**RE: ADDENDUM TO THE BAT SPECIALIST IMPACT ASSESSMENT FOR THE PROPOSED WIND GARDEN WIND FARM IN THE EASTERN CAPE.**

**Wind Garden WEF**  
**Basic Assessment Report Addendum**

**Addendum Constraints Map**  
Figure 1

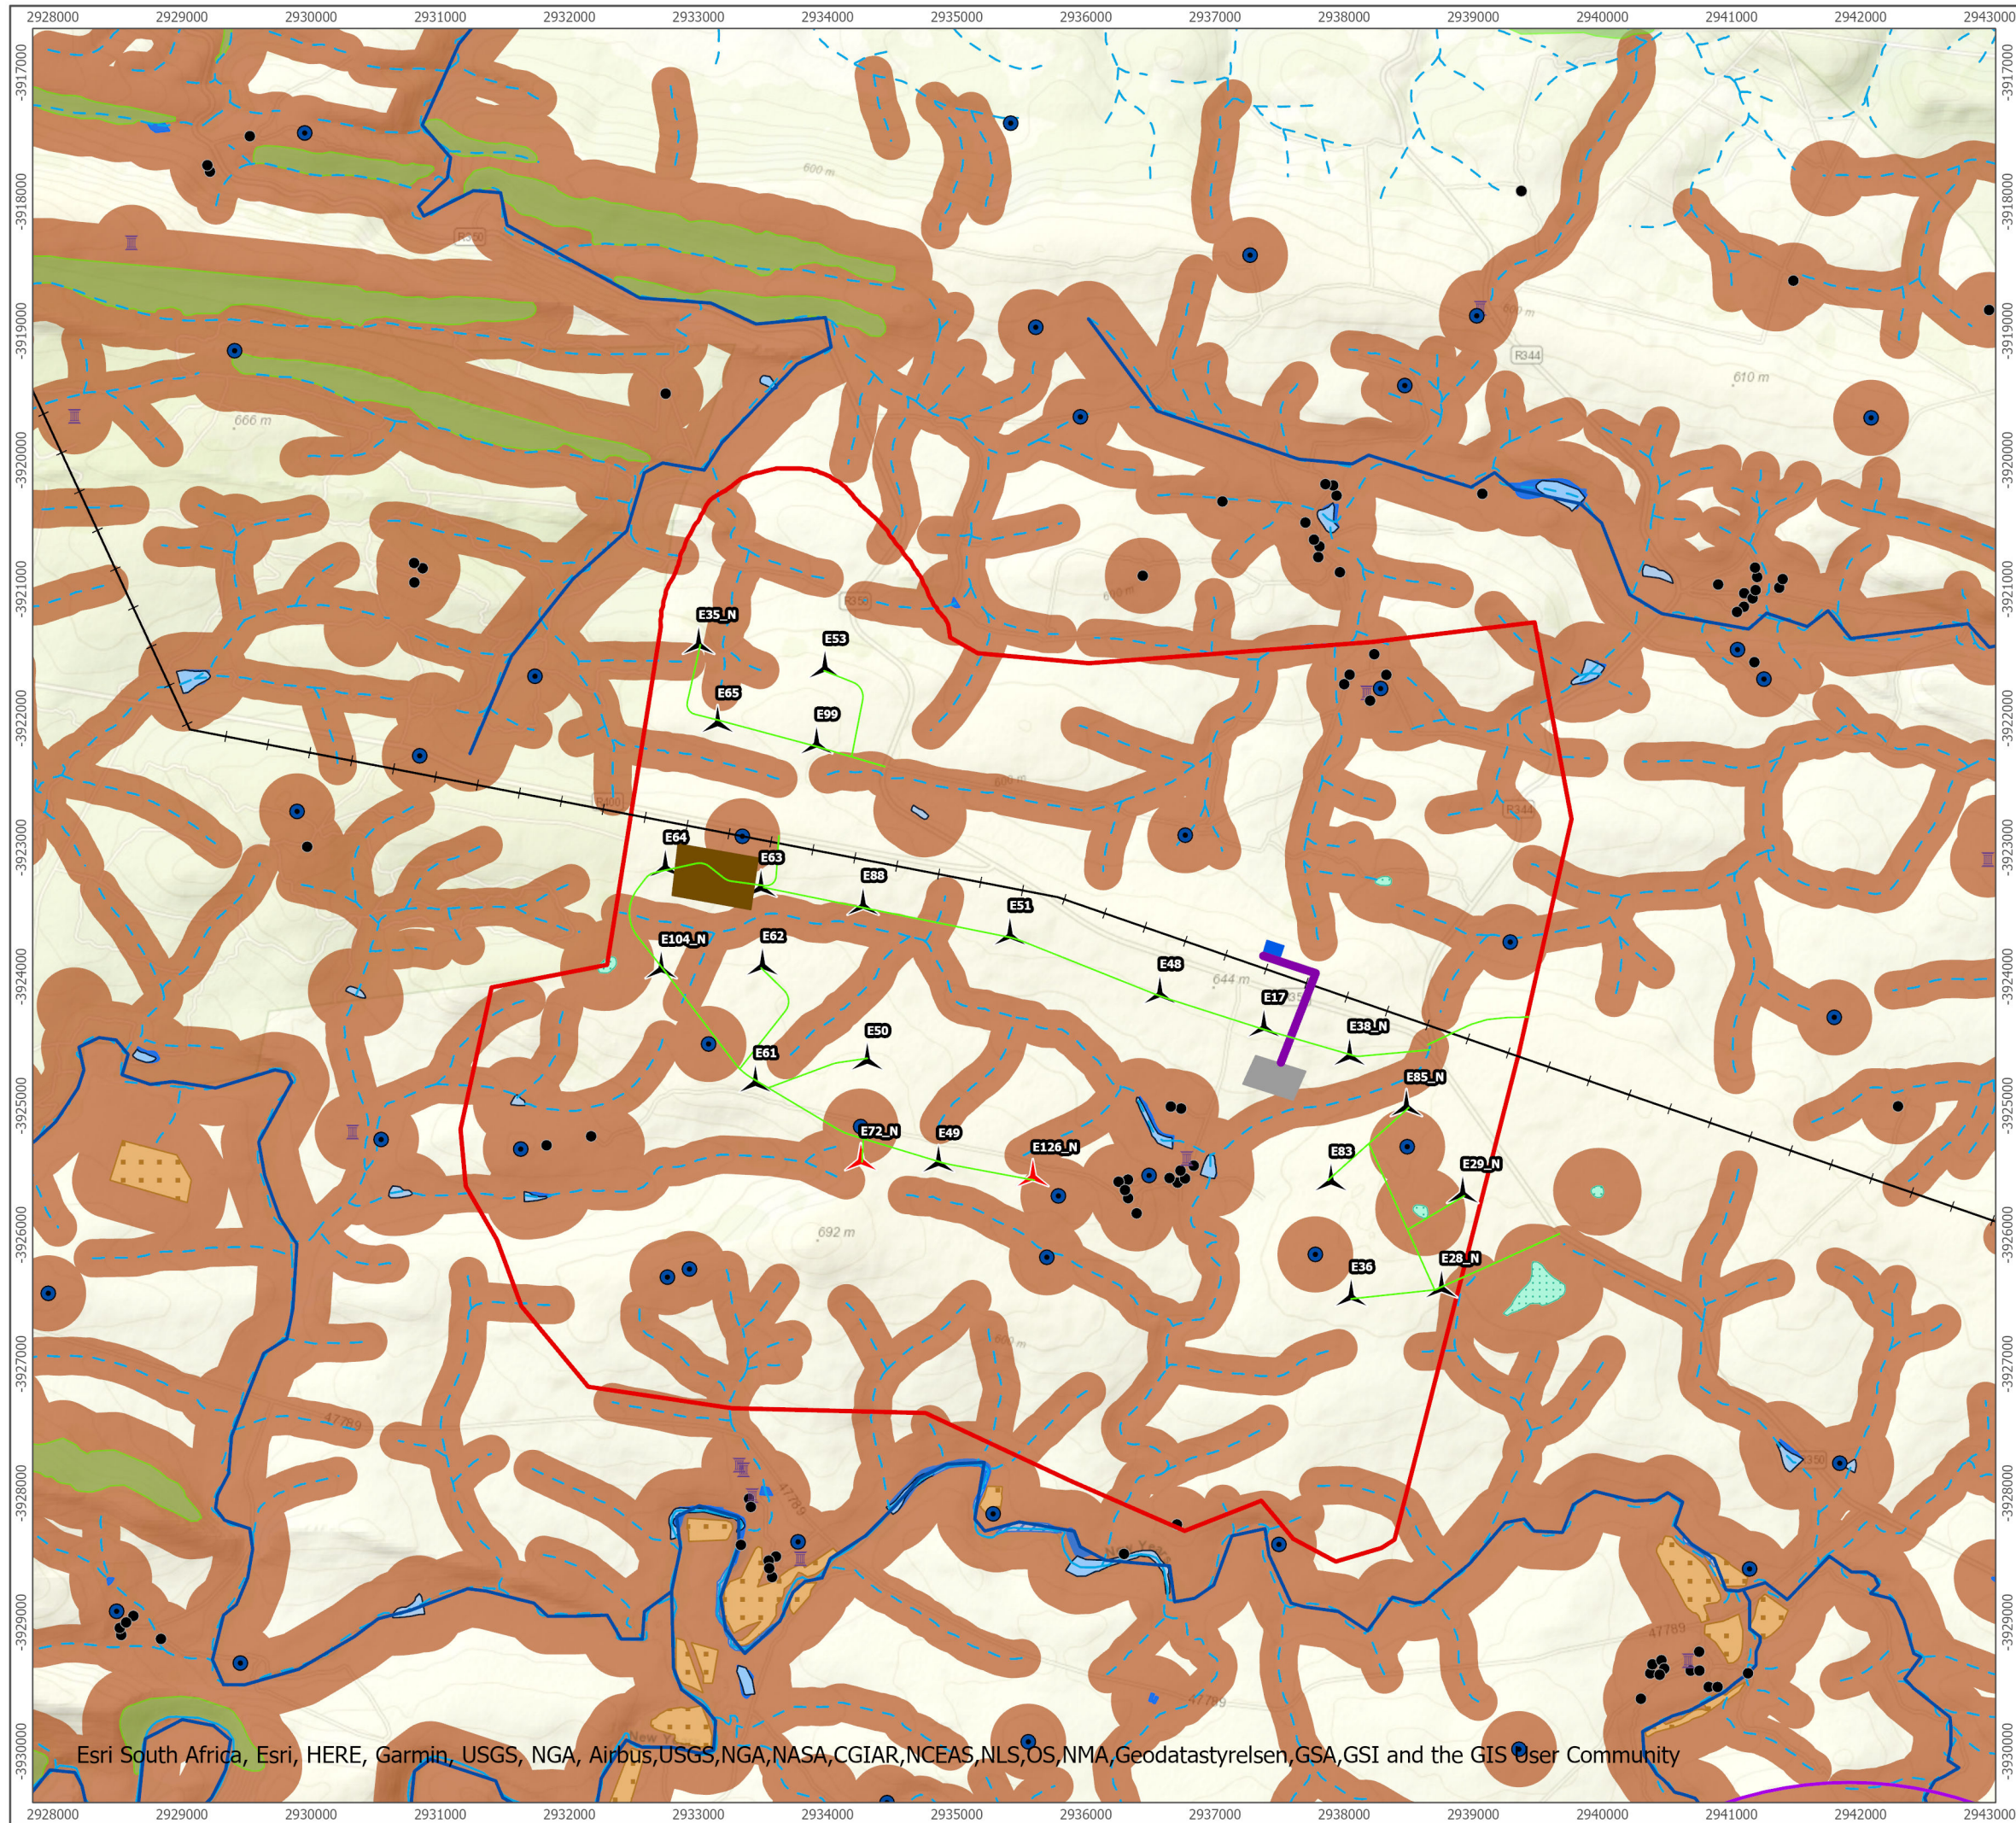
The overall reduction in turbines is considered a positive change for the proposed facility, in terms of its potential impacts to bats. This change may potentially decrease the risks associated with bats and wind turbines in the area. However, with the reduction and alteration of the facility layout, two turbines (E72\_N and E126\_N) in the new layout have slightly moved from their original positions and now encroach into bat No-Go areas for wind turbines (Figure 1). Although the reduction in the overall number of turbines could potentially reduce the overall impact on bats in the area, which is seen as a positive impact, it must be noted that a single badly placed turbine may potentially have more significant impacts on bats than the remainder of turbines combined.

Nonetheless, given that these buffers are being encroached by Turbine E72\_N, at 239m from a water reservoir, and Turbine E126\_N, at 221m from a water reservoir (as well as both buffers being associated with man-made water reservoirs), it is considered acceptable that these two wind turbines may stay in their currently proposed positions, provided that strict mitigation measures are applied to reduce impacts to bats. Specific protocols would need to be followed for these reservoirs, including either completely covering, replacing or demolishing the identified features associated with these no-go areas. By doing so, this would allow for such features to not be used by bats, subsequently leading to reduced usage of the area near the proposed wind turbine locations. As such, these reservoirs would need to be completely covered, replaced with fully enclosed tanks (without the opportunity to be accessed by bats), or potentially demolished to

prevent any usage by bats for drinking purposes – ultimately reducing the sensitivity of the area. Such mitigation measures are considered a pre-requisite for the placement of these two wind turbines (E72\_N and E126\_N) within these sensitive feature buffers, and only applies to those features and areas identified.
